DOCUMENT CHANGE REQUEST

DCR number 521		Changes required for: Qualification		Originator: AXON CABLES SAS (F.	
Date: 2009/05/29		Date sent: 2009/05/29		Organisation: CNES	
Status: IMPLEMENTED

Title:	Wires and Cables, Fluoropolymer Insulated, Low Frequency, 600V, -200 to + 200 degC, Based on				
Number:	3901/024	Issue:	1

TABLE 1(a) - TYPE VARIANTS (CONTINUED)

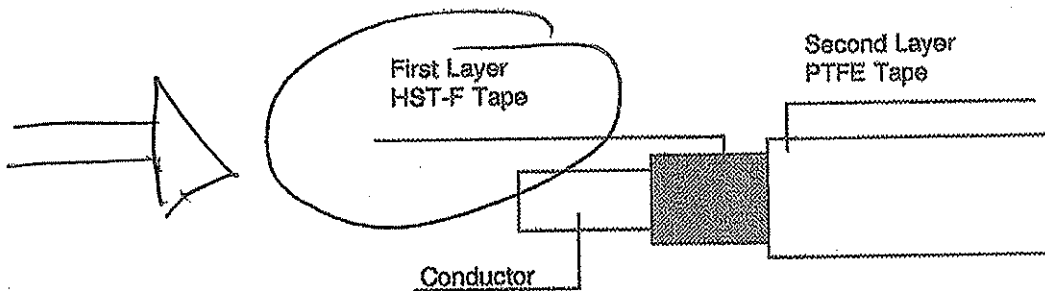
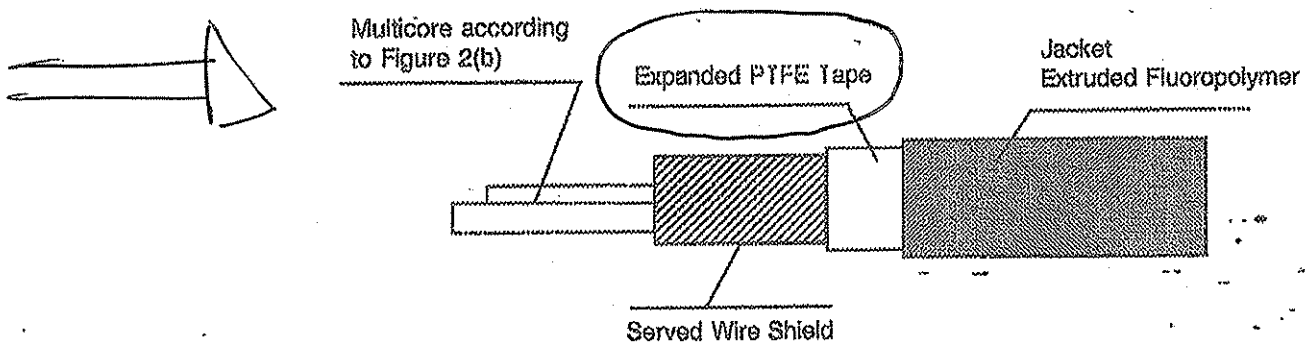
Weight of variante 53

The weight of the variante 53 is given at 21 grs/meter maximum. The current weight measured by AXON CABLE is 23.62 with "nominal" dimensions.
The theoretical calculation with the maximum dimension give 24.35 grs/meter
We propose to increase the weight at 24.30 grs/meter

24,30
